Re: Five-Year Review Report Concurrence, 19th Avenue Landfill, Phoenix, AZ

Second Five-Year Review Report For 19th Avenue Landfill, NPL Site, Phoenix, AZ

September 16, 2005

Figure
A

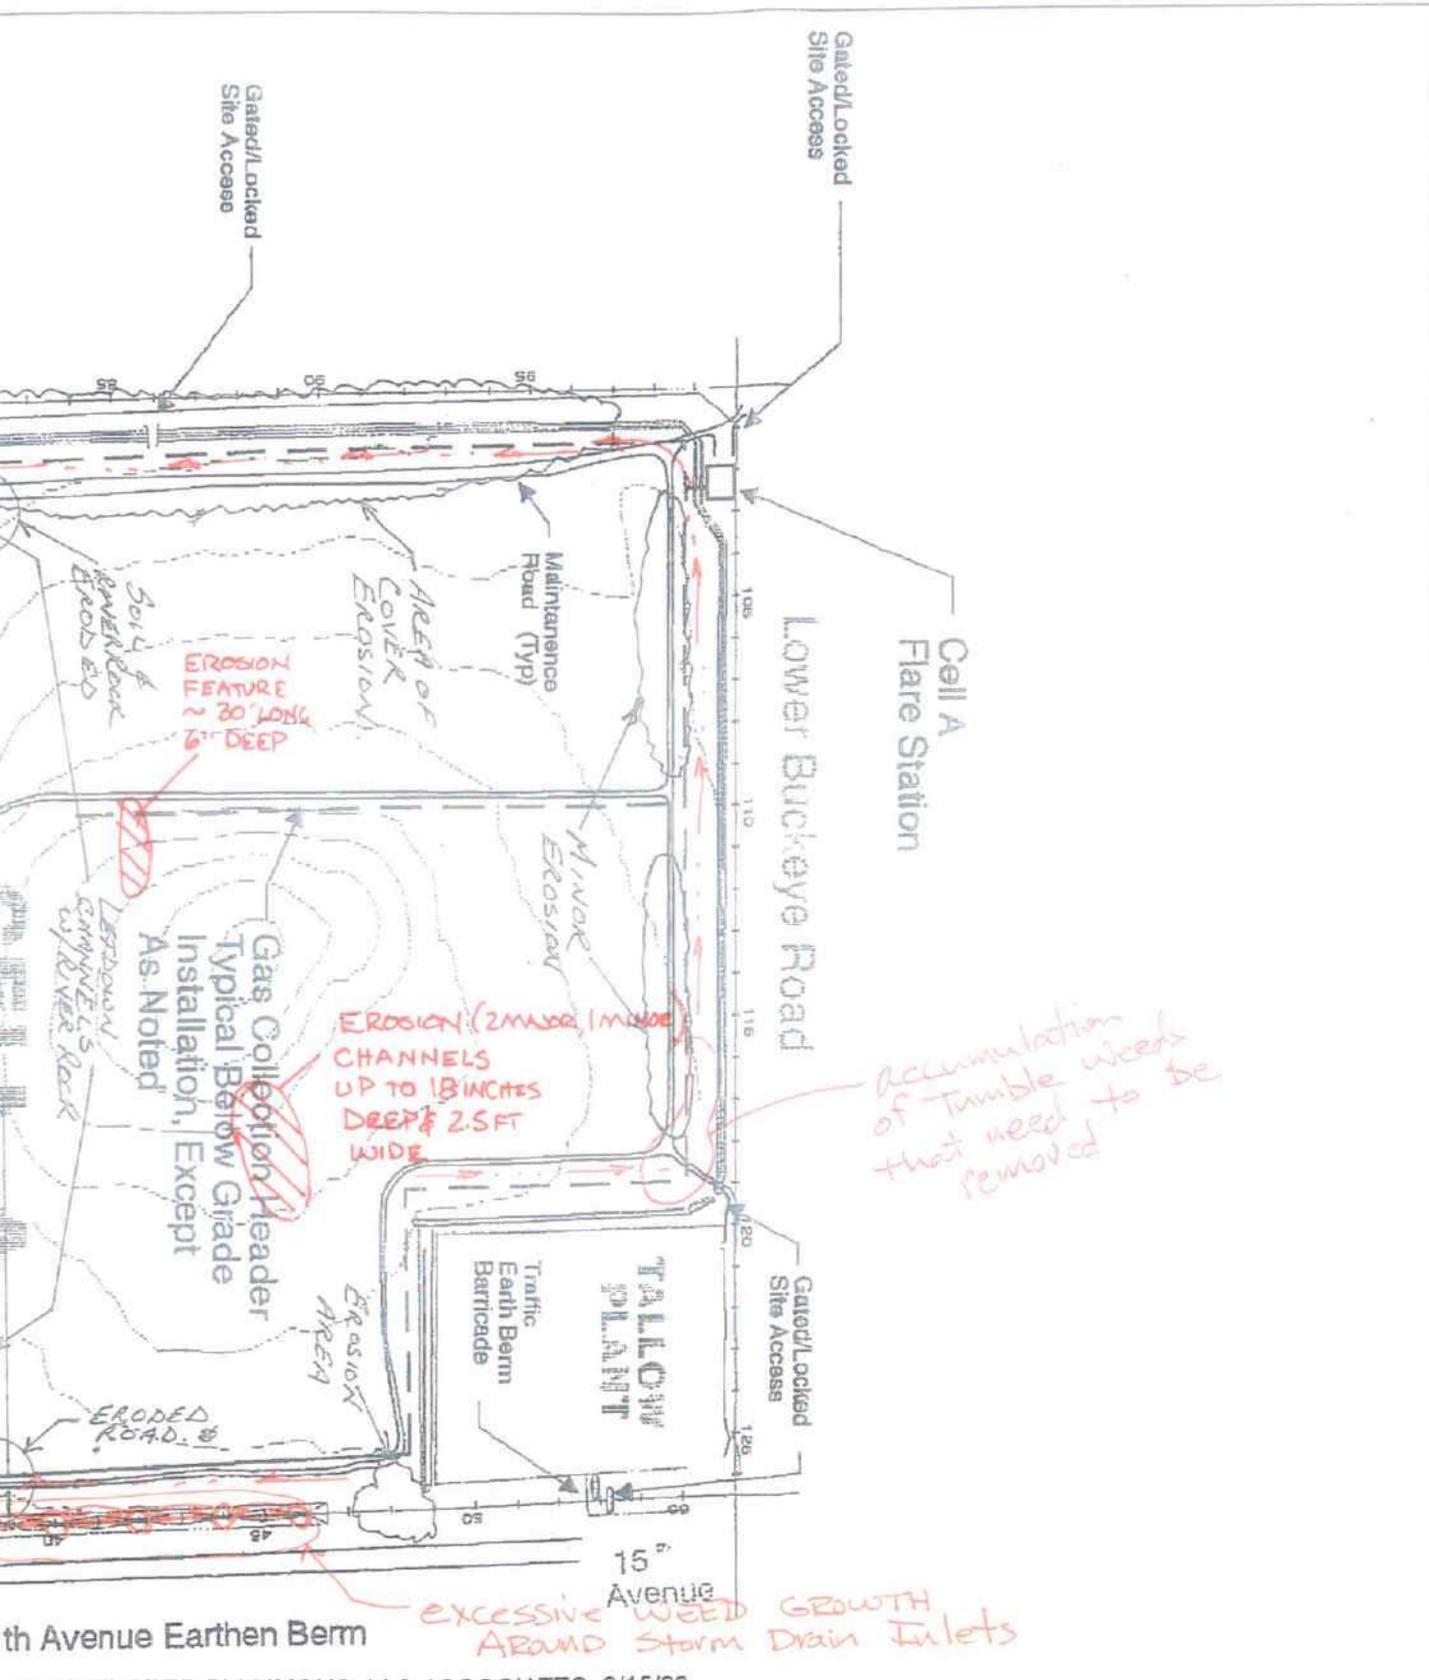
Gas Treatment System: REMOVE OR REPLACE NON FUNCTIONING GAGE.

Site Access: ADD APPROPRIATE SIGNAGE
